**SUBJECT: Terminal 3 & Terminal 4 Shore Power Project  
CONTRACT NO. 071664**

**ADDENDUM NUMBER # 02**

This addendum is issued to add, revise, remove, and clarify the following:

**PIER 3 SHORE POWER ONE-LINE DIAGRAM - SHEET 1**  
NO SCALE

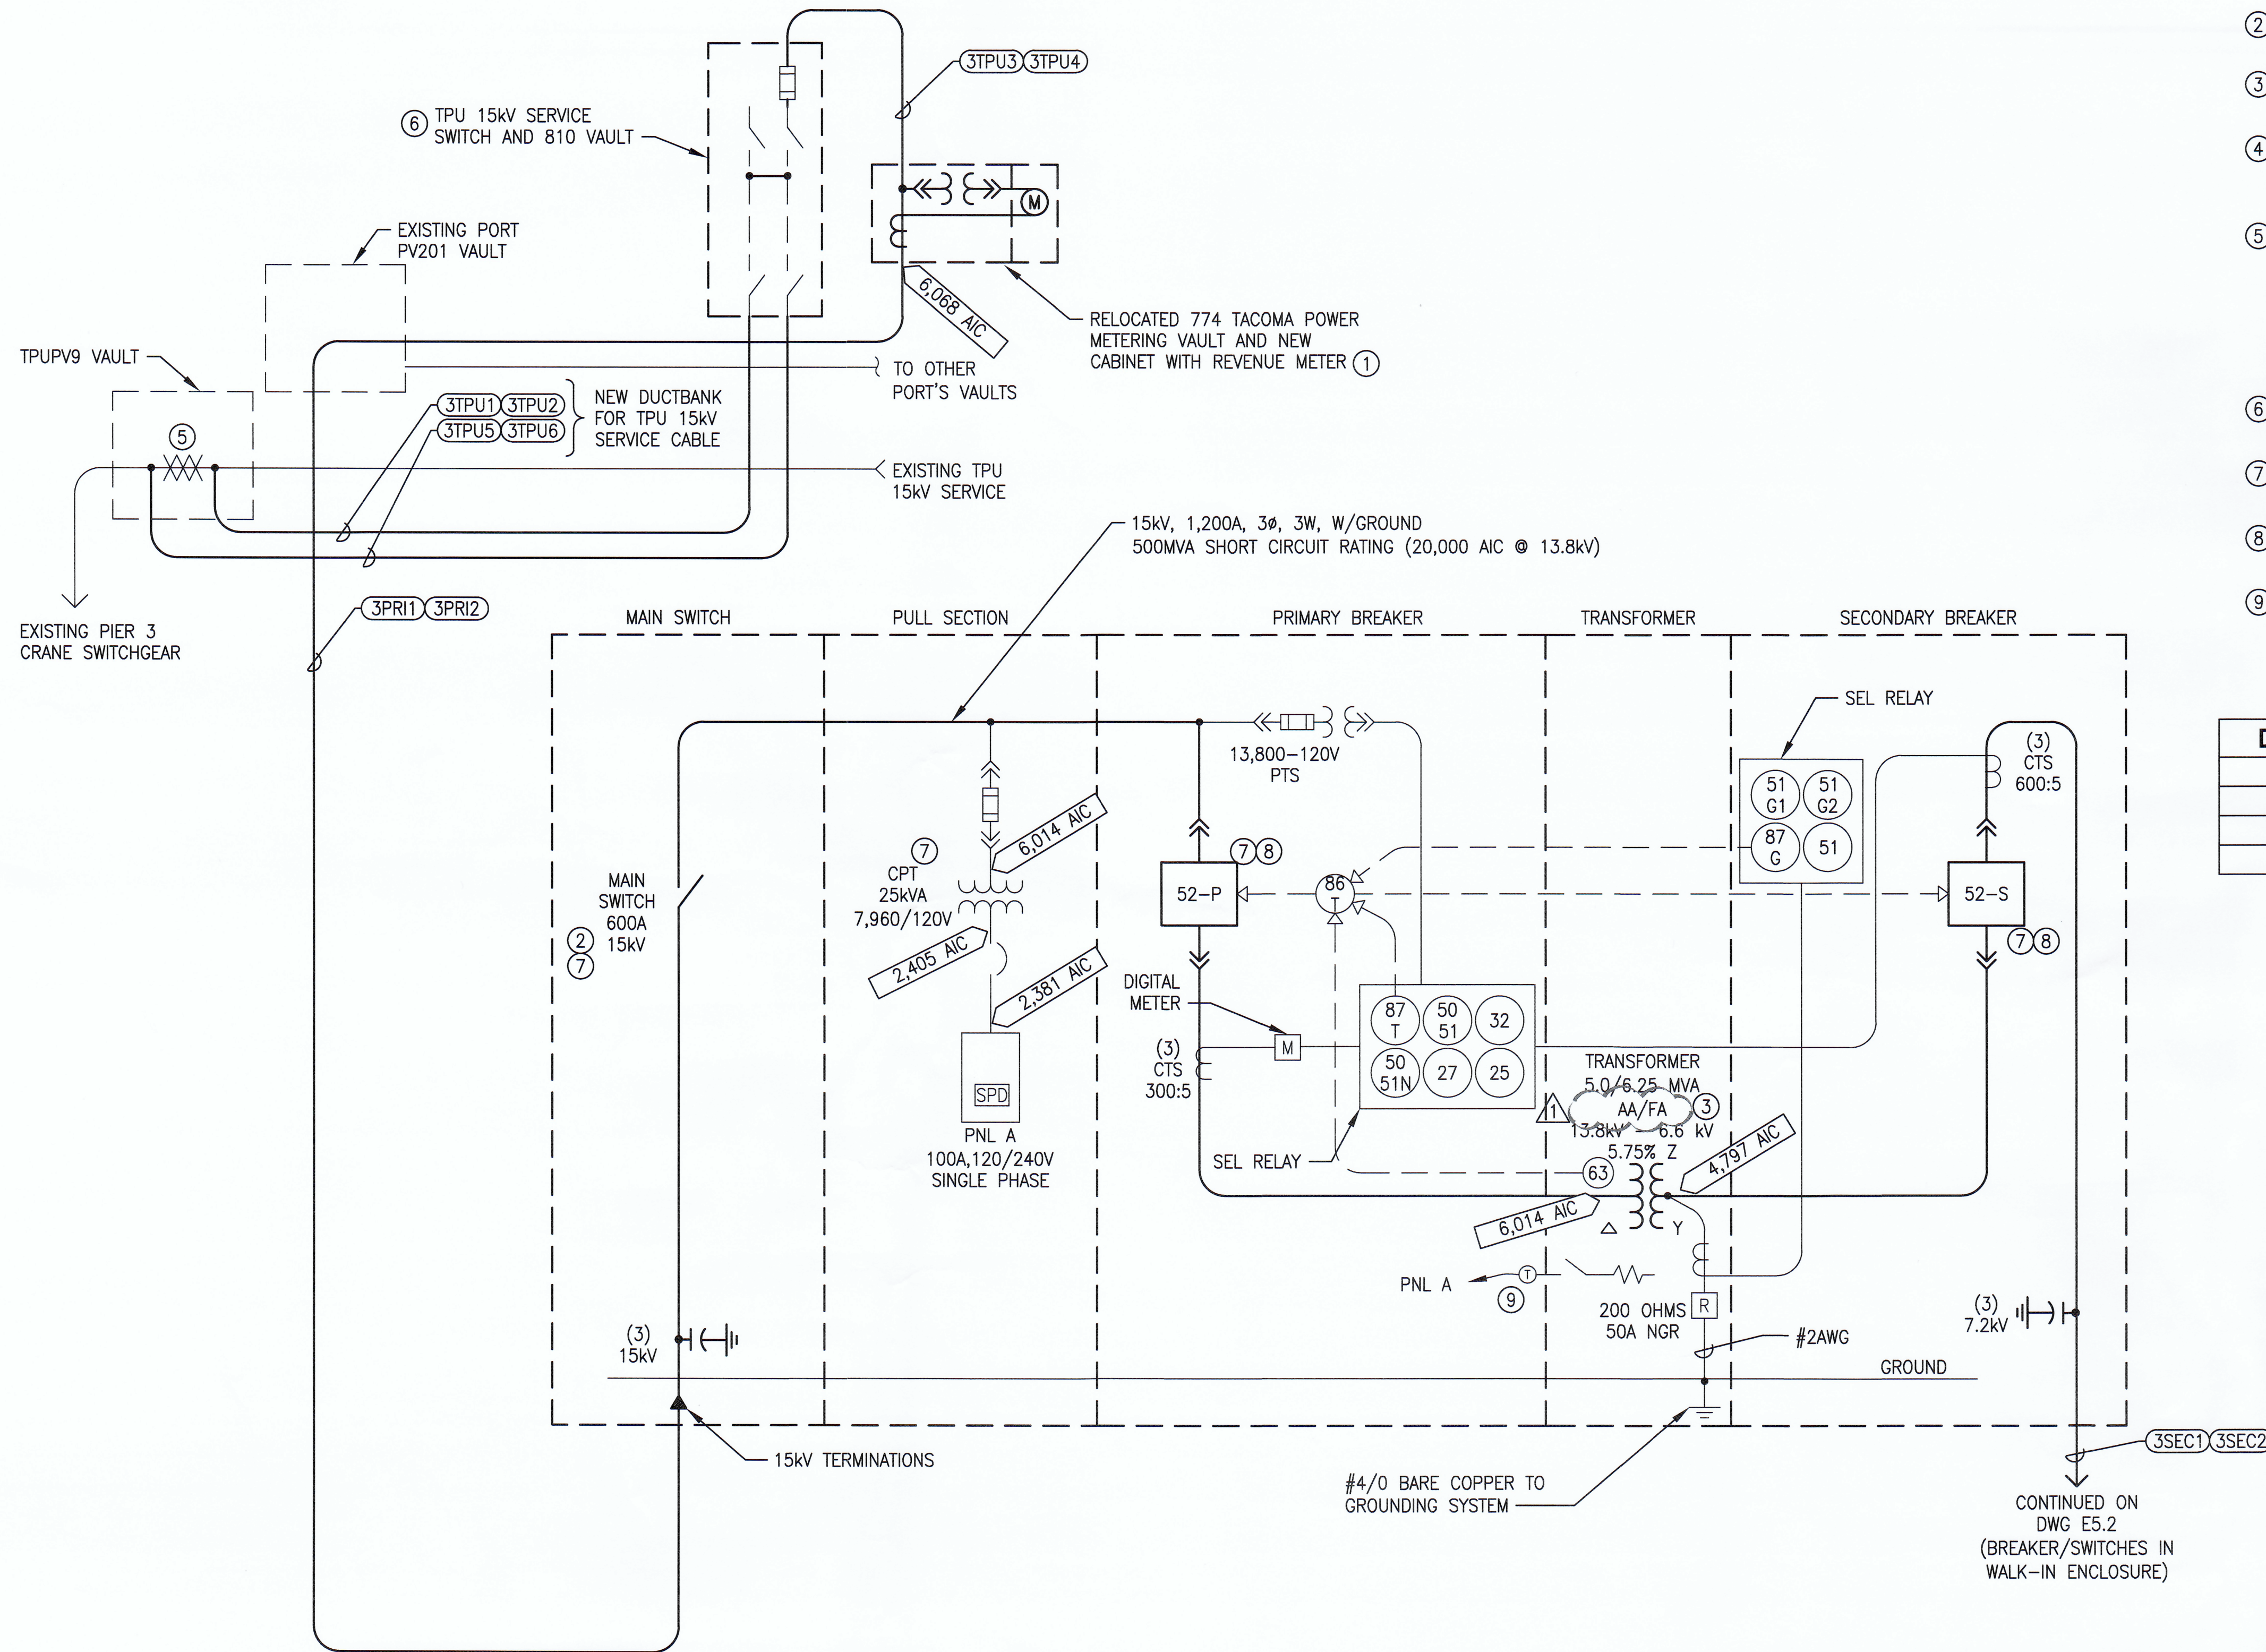
#### **SHEET E5.1 – Pier 3 Shore Power One-Line Diagram – Sheet 1**

- Clarify that medium voltage (MV) substation transformers are dry-type.
- Revise to reflect new contract number 071664.

**PIER 4 SHORE POWER ONE-LINE DIAGRAM - SHEET 1**  
NO SCALE

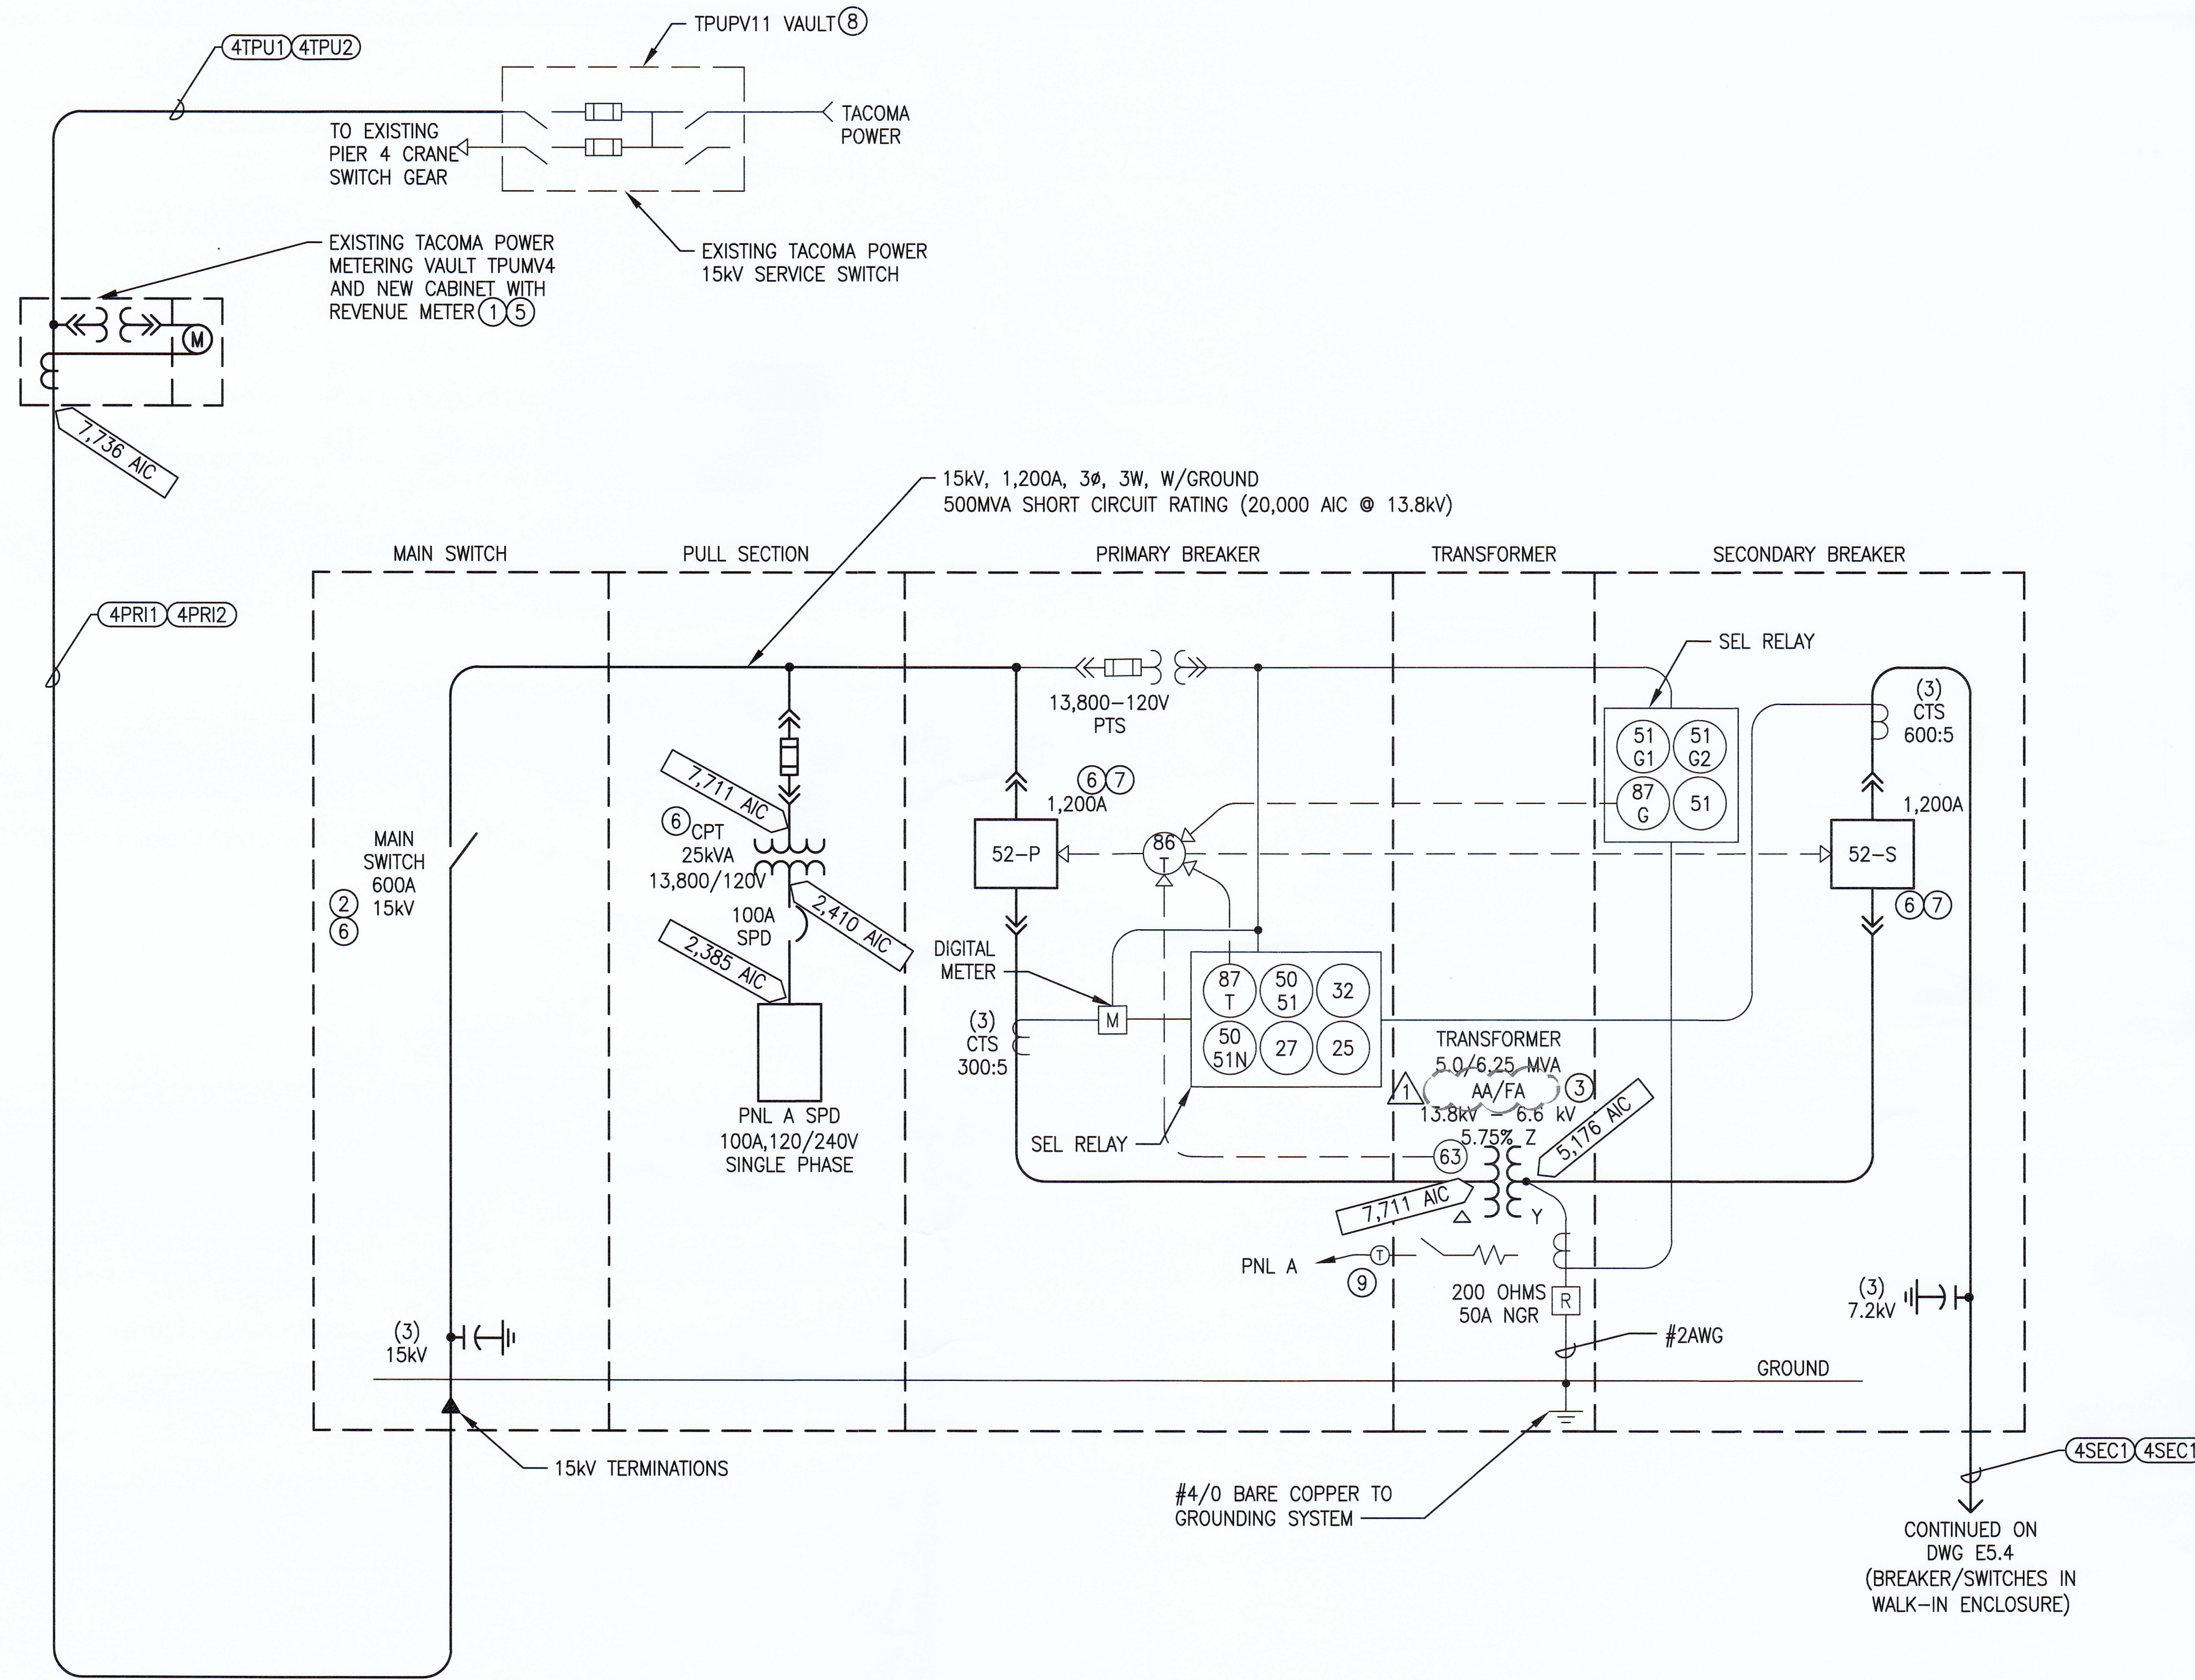
#### **SHEET E5.3 – Pier 4 Shore Power One-Line Diagram – Sheet 1**

- Clarify that medium voltage (MV) substation transformers are dry-type.
- Revise to reflect new contract number 071664.
